Rezoning Application: PD 25-0457
Zoning Hearing Master Date: July 21, 2025
BOCC Hearing Meeting Date: September 9, 2025

**Hillsborough
County Florida**

Development Services Department

1.0 APPLICATION SUMMARY

2.4 Proposed Site Plan (partial provided below for size and orientation purposes. See Section 8.0 for full site plan)

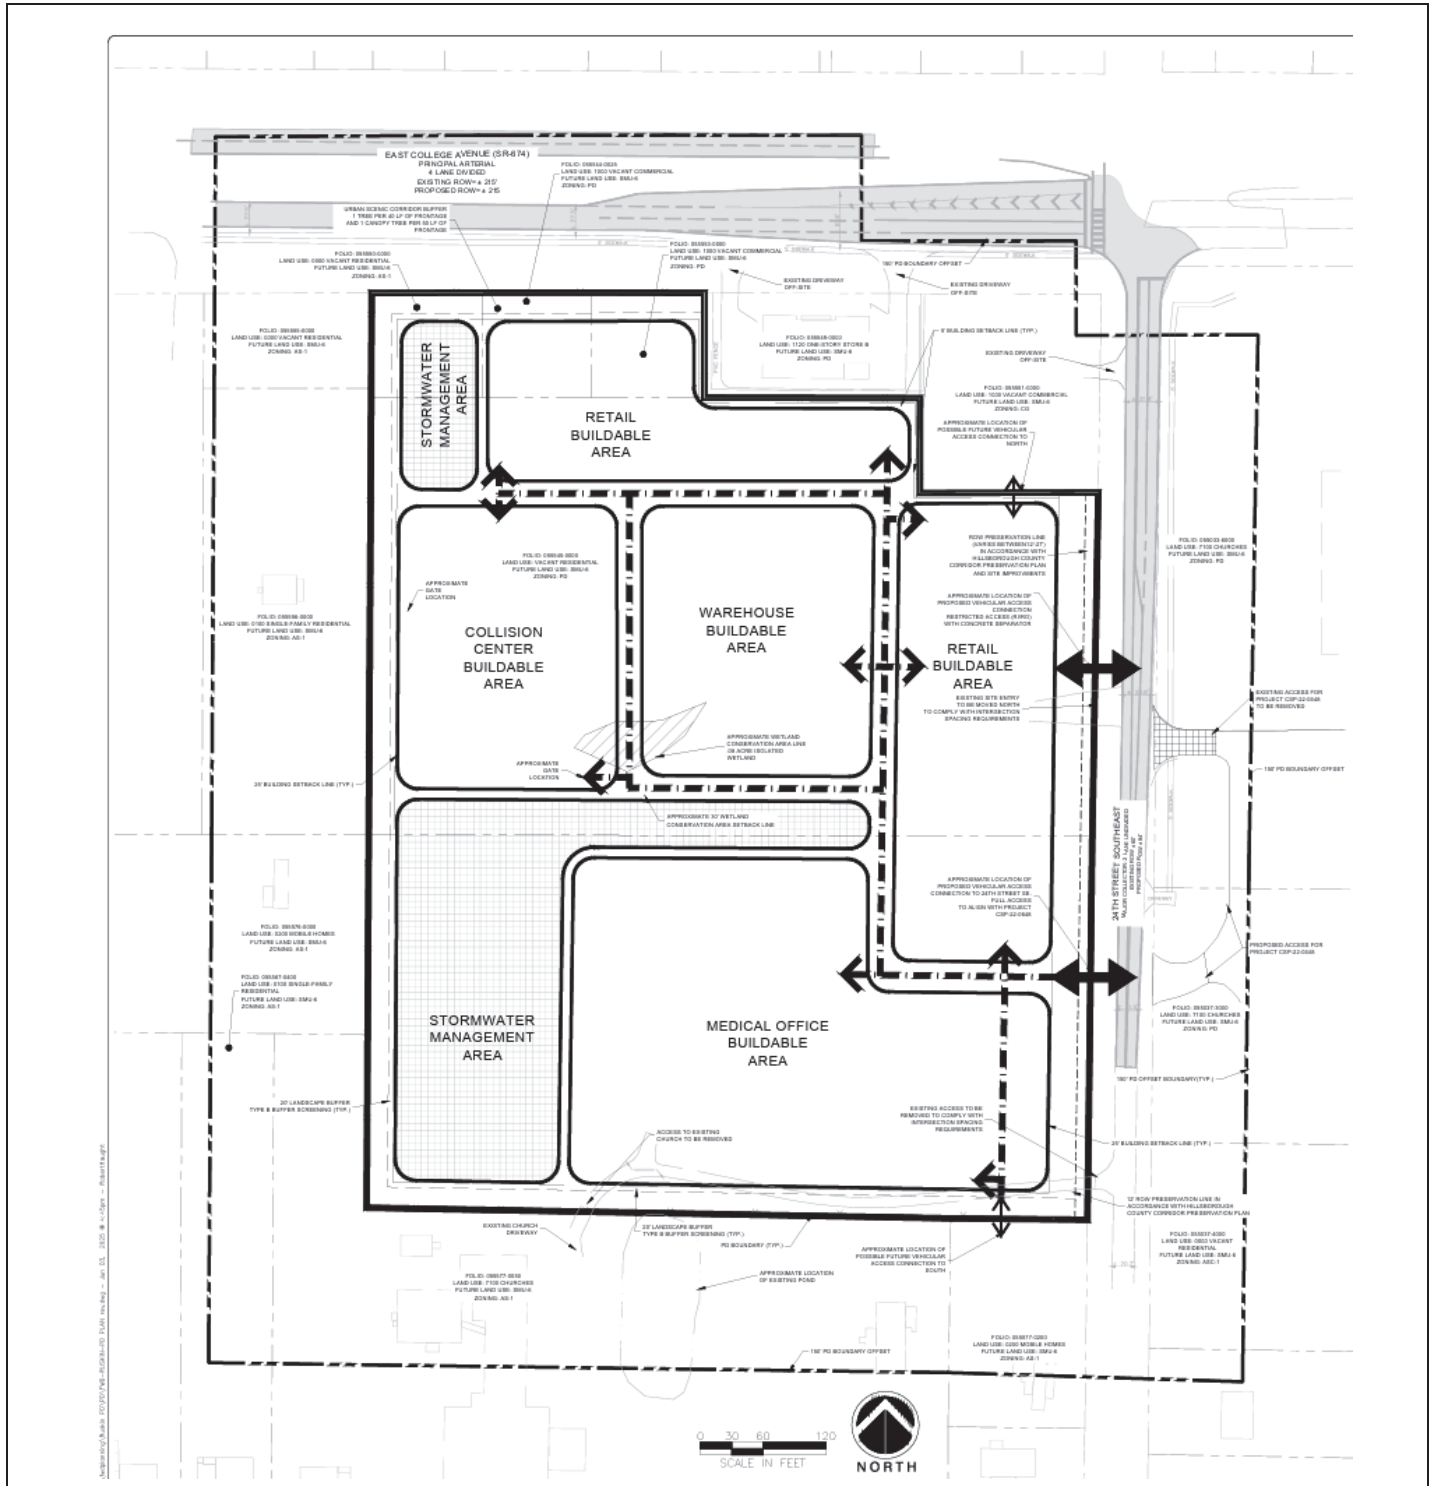
1. Revise the PD site plan label stating "APPROXIMATE LOCATION OF PROPOSED VEHICULAR ACCESS CONNECTION RESTRICTED ACCESS (RI/RO)" to state "APPROXIMATE LOCATION OF PROPOSED VEHICULAR ACCESS CONNECTION RESTRICTED ACCESS (RI/RO) WITH CONCRETE SEPARATOR".

2. Revise the PD site plan note north of the northern project access stating "12' ROW PRESERVATION LINE IN ACCORDANCE WITH HILLSBOROUGH COUNTY CORRIDOR PRESERVATION PLAN" to state, "ROW PRESERVATION LINE (VARIES BETWEEN 12'-27') IN ACCORDANCE WITH HILLSBOROUGH COUNTY CORRIDOR PRESERVATION PLAN AND SITE IMPROVMENTS".

3. Revise the PD site plan note south of the southern project access point stating "ROW PRESERVATION LINE (VARIES BETWEEN 12'-27') IN ACCORDANCE WITH HILLSBOROUGH COUNTY CORRIDOR PRESERVATION PLAN AND SITE IMPROVMENTS" to state "12' ROW PRESERVATION LINE IN ACCORDANCE WITH HILLSBOROUGH COUNTY CORRIDOR PRESERVATION PLAN".

4. Revise the PD site plan label stating "APPROXIMATE LOCATION OF POSSIBLE FUTURE VEHICULAR ACCESS CONNECTION TO SOUTH" to state, "APPROXIMATE LOCATION OF VEHICULAR AND PEDESTRIAN CROSS ACCESS CONNECTION TO SOUTH".

5. Revise the PD site plan label stating "APPROXIMATE LOCATION OF POSSIBLE FUTURE VEHICULAR ACCESS CONNECTION TO NORTH" to state, "APPROXIMATE LOCATION OF VEHICULAR AND PEDESTRIAN CROSS ACCESS CONNECTION TO NORTH".

6. Change Warehouse to Contractor's Office / Warehouse.
7. Change Collision Center to Collision Center/Motor Vehicle Repair, Major and including body work and/or painting.

SOUTH SHORE PD Project Site General Development Plan

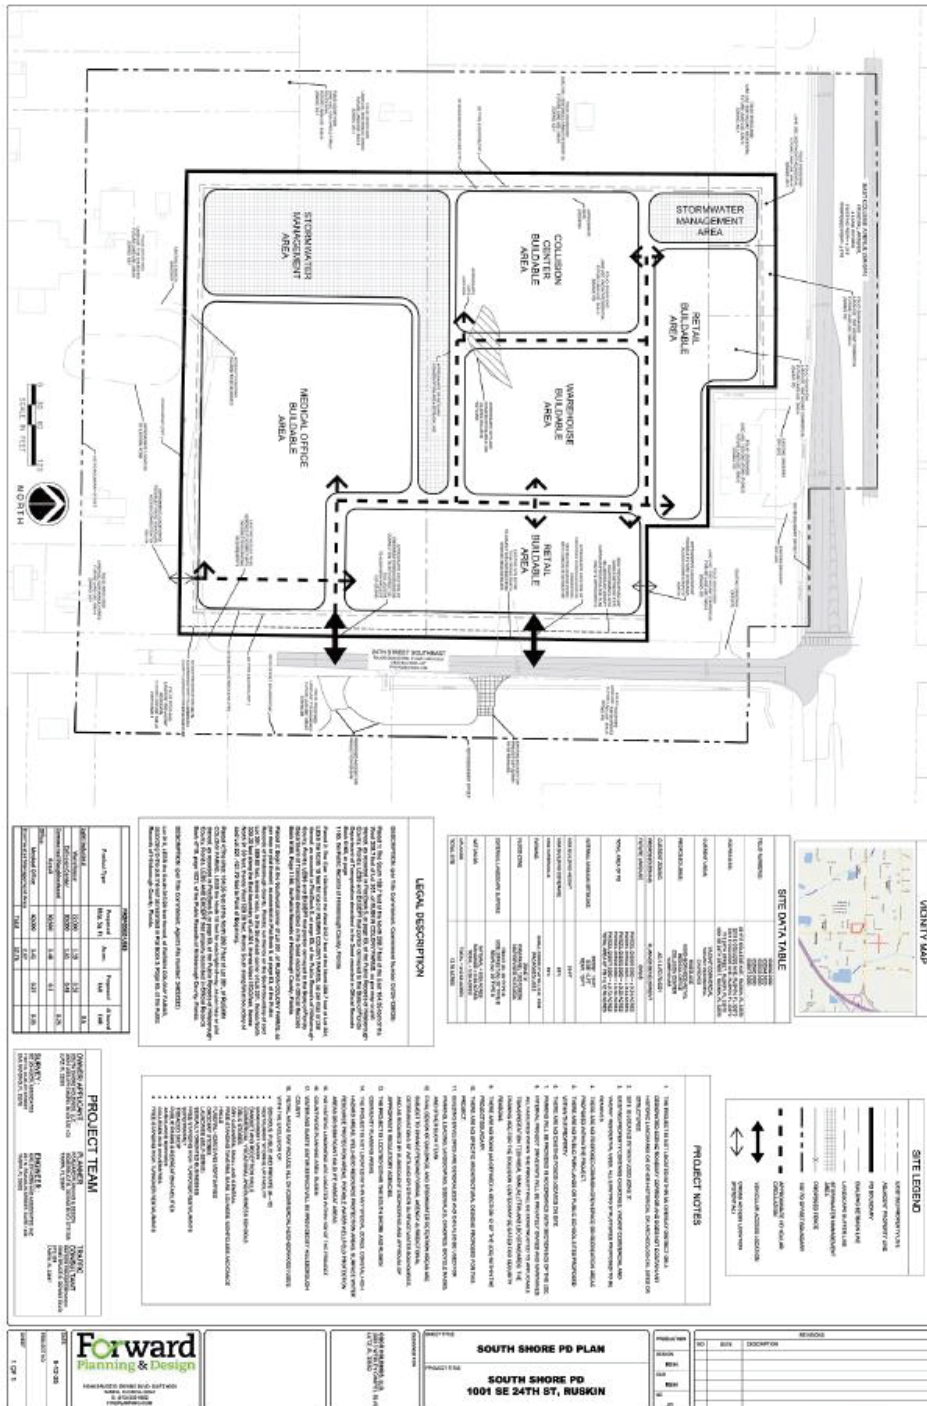
The subject project site is located southwest of the intersection of College Avenue (State Road 674) & 24th Street SE, in Hillsborough County, Florida; as shown in [ATTACHMENT A](#). The subject ±12.76 acre project site is currently zoned AS-1 (0.24 acres) & PD 78-0221 (12.52 acres). A Planned Development (PD) rezoning is proposed which would allow for the following mixed use development scenario: (a) Specialty Trade Contractor / Warehouse @ 22,000 square feet, (b) Medical Office @ 40,000 square feet, (c) Commercial/Retail @ 30,500 square feet, and (d) Automobile Collision Center @ 30,000 square feet. Access to the project site is planned to be provided via two (2) driveway connections to 24th Street SE, with the northern site access driveway restricted to right-in/right-out traffic movements, and the southern site access driveway providing for full access; as shown in [ATTACHMENT B](#).

In addition, a concrete separator will be installed by the developer on 24th Street SE in the vicinity of the northern site access driveway connection to physically restrict left turn movements; with the specific design of the separator to be determined during site plan permitting.

I have found the attached Design Exception (DE) for PD 25-0457 APPROVABLE.
